Access Compliance Report

Public Rights-of-Way

Intersection ID: 43665	Main Street: HUNTINGTON_MEADOW_LN	Cross Street: STEELE_CREEK_RD	Location: SE
ADA ID: C8D12C537ECB	Ramp Type: PerpDiag	Initial Pass/Fail: Fail	Overall Compliance: No
Severity Score: 22.5			
Codes/Mitigation Info/Possible Solution		Field Measurements/Component Compliance

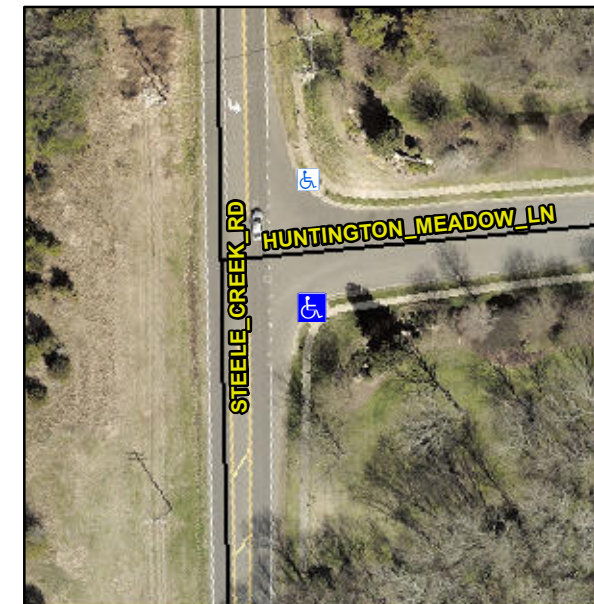
R304.5.1, R304.2.2, R304.5.3

Compliance	Description	Data	Compliance	Description	Data
N/A	Ramp Length (in)	16.5	No	Ramp Slope (%)	10.4
No	Ramp Width (in)	41.0	No	Ramp XSlope (%)	4.9
N/A	Flare Type LT	N/A	N/A	Flare Type RT	N/A
N/A	Flare Slope LT (%)	N/A	N/A	Flare Slope RT (%)	N/A
N/A	Flare Traversable LT?	N/A	N/A	Flare Traversable RT?	N/A
N/A	Landing Length (in)	N/A	N/A	DWS Provided?	N/A
N/A	Landing Width (in)	N/A	N/A	DWS Contrast?	N/A
N/A	Landing Slope (%)	N/A	N/A	DWS Length (in)	N/A
N/A	Landing X Slope (%)	N/A	N/A	DWS Full Width?	N/A
N/A	Landing Curb? (Y/N)	N/A	N/A	DWS Offset (in)	N/A
N/A	Shared Landing?	N/A			
N/A	Gutter Ponding?	N/A	N/A	Gutter Slope (%)	N/A
N/A	Gutter Lip Ht (in)	N/A	N/A	Gutter X Slope (%)	N/A
N/A	Painted X Walk1?	No	N/A	Painted X Walk2?	No
	X Walk 1 Direction	To N		X Walk 2 Direction	To W
N/A	X Walk 1 Width (in)	N/A	N/A	X Walk 2 Width (in)	N/A
	X Walk 1 Slope (%)	2.0		X Walk 2 Slope (%)	3.8
	X Walk 1 X Slope (%)	2.2		X Walk 2 X Slope (%)	0.7

Remove & Replace Curb Ramp With Two New Directional Ramps or Equivalent.
